City of Aventura
 Community Development Department
 Building Division
 19200 W Country Club Drive
 Aventura, FL 33180
 305.466.8937 | permits@cityofaventura.com

NOTICE TO THE CITY OF AVENTURA BUILDING DIVISION OF EMPLOYMENT AS SPECIAL INSPECTOR UNDER THE FLORIDA BUILDING CODE

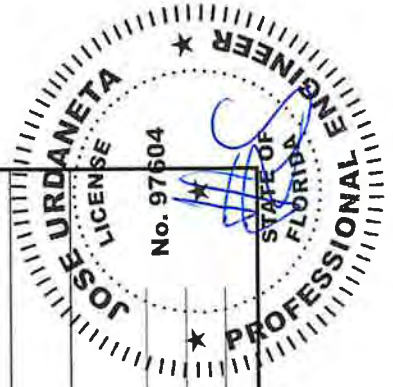
Other comments:

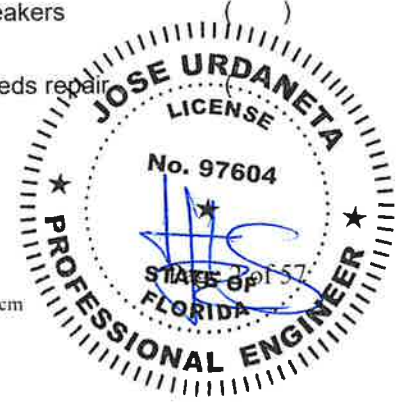
Comments: Located inside the electrical room at ground level of South building tower III.

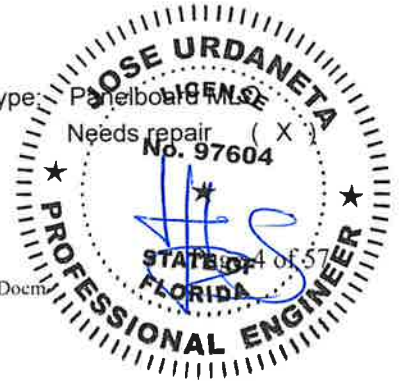
1. Panel #: No label Size: No ratings Phases: 3 Type: Panelboard MLO
 Location: North wall – Main electrical room Good () Needs repair (X)
 Comments: Panel requires repairs: (Annex "A", Photo # 14)
 a. Missing identification (label).
 b. Panel is missing cover shield, exposing live parts.
 c. Panel must be reverted to its original permanent condition.

2. Panel #: No label Size: 100 AMP Phases: 3 Type: Panelboard MLO
 Location: North wall – Main electrical room Good () Needs repair (X)
 Comments: Panel requires repairs: (Annex "A", Photo # 15)
 a. Missing identification (label).
 b. Missing circuit directory.
 c. Working space clearance violation. (Annex "A", Photo # 16)

3. Pane #: No label Size: 150 AMP Phases: 3 Type: Panelboard MCB-150
 Location: North wall – Main electrical room Good () Needs repair (X)
 Comments: Panel requires repairs: (Annex "A", Photo # 17)
 a. Missing identification (label).
 b. Missing circuit directory.
 c. Missing cover shield.

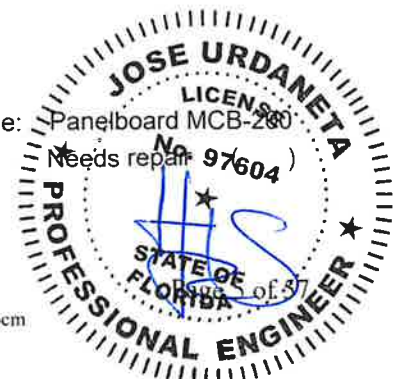
15. Panel#: Sub panel 1	Size: 125 AMPS	Phases: 3	Type: Panelboard MCB-100
Location: Roof CT Mechanical Room	Good	()	Needs repair (X)
Comments: Panel requires repairs: (Annex "A", Photo # 29)

a. Opening in circuit space.			
16. Panel#: Sub panel 2	Size: 100 AMPS	Phases: 3	Type: Panelboard MLO
Location: Roof CT Mechanical Room	Good	()	Needs repair (X)
Comments: Panel requires repairs: (Annex "A", Photo # 30)

a. Missing circuit directory.			
17. Panel#: No label	Size: 225 AMPS	Phases: 3	Type: Panelboard MLO
Location: Tower 1 Laundry room level 14	Good	()	Needs repair (X)
Comments: Panel requires repairs: (Annex "A", Photo # 31)

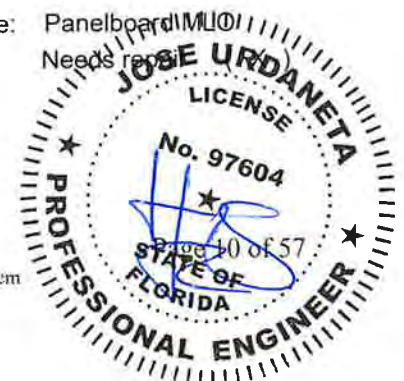
49. Panel#: No label Size: No ratings Phases: 3 Type: Panelboard MLO
Location: Roof CT mechanical room Good () Needs repair (X)
Comments: panel requires repairs. (Annex "A", Photo # 62)

a. Missing identification label.
b. Missing circuit directory.
c. Opening in circuit space.
50. Panel#: No label Size: No ratings Phases: 3 Type: Panelboard MLO
Location: Roof CT mechanical room Good () Needs repair (X)
Comments: Panel requires repairs: (Annex "A", Photo # 63)

a. Missing identification label.
b. Missing circuit directory.
c. Opening in circuit space.
51. Panel#: No label Size: 600 AMP Phases: 3 Type: Panelboard MLO
Location: Roof CT mechanical room Good () Needs repair (X)
Comments: This is a combo panel/motor control center It requires repairs: (Annex "A", Photo # 64)

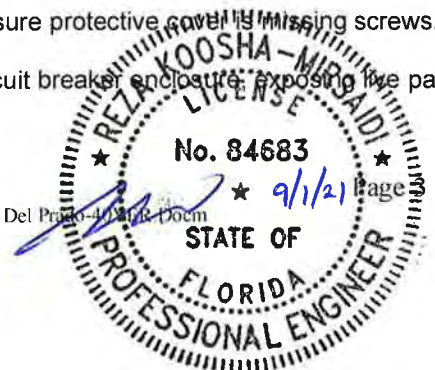
Comments: Located inside the main switchgear room (South wall) at ground level of South building. 480v 3Φ. Must be identified as "Main X of X" and indicate what panel or load it serves. Other mains in this electrical room could not be identified. All enclosures have been painted without preserving the identification and the rating of the enclosed equipment; nameplates have been removed. There is no tag or label or nameplate of any kind that allows for proper identification. (Annex "A", Photo # 3)

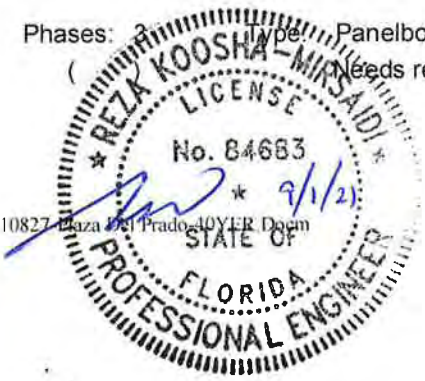
4. Panel #: No label Size: 100 AMP Phases: 3 Type: Panelboard MCB-100
 Location: North wall – Main electrical room Good () Needs repair (X)
 Comments: Panel requires repairs: (Annex "A", Photo # 18).

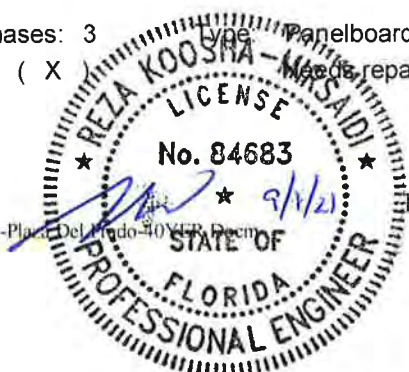
15. Panel#:	Sub panel 1	Size:	125 AMPS	Phases:	3	Type:	Panelboard MCB-100
Location:	Roof CT Mechanical Room		Good	()	Needs repair	(X)
Comments:	Panel requires repairs: (Annex "A", Photo # 29)

a. Opening in circuit space.						
16. Panel#:	Sub panel 2	Size:	100 AMPS	Phases:	3	Type:	Panelboard MLO
Location:	Roof CT Mechanical Room		Good	()	Needs repair	(X)
Comments:	Panel requires repairs: (Annex "A", Photo # 30)

a. Missing circuit directory.						
17. Panel#:	No label	Size:	225 AMPS	Phases:	3	Type:	Panelboard MLO
Location:	Tower 1 Laundry room level 14		Good	()	Needs repair	(X)
Comments:	Panel requires repairs: (Annex "A", Photo # 31)

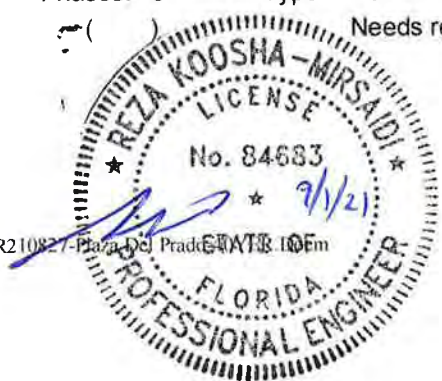
53. Panel#: No label Size: 225 AMP Phases: 3 Type: Panelboard MLO
Location: Tower 1 Laundry room level 4 Good () Needs repair (X)
Comments: Panel requires repairs: (Annex "A", Photo # 68)
a. Missing identification (label).
b. Missing circuit directory.

54. Panel#: No label Size: 225 AMP Phases: 3 Type: Panelboard MLO
Location: Tower 2 Laundry room level 14 Good () Needs repair (X)
Comments: Panel requires repairs: (Annex "A", Photo # 69)
a. Missing identification (label).

55. Panel#: No label Size: 225 AMP Phases: 3 Type: Panelboard MLO
Location: Tower 2 Laundry room level 4 Good () Needs repair (X)
Comments: Panel requires repairs: (Annex "A", Photo # 70)
a. Missing identification (label).
b. Missing circuit directory.
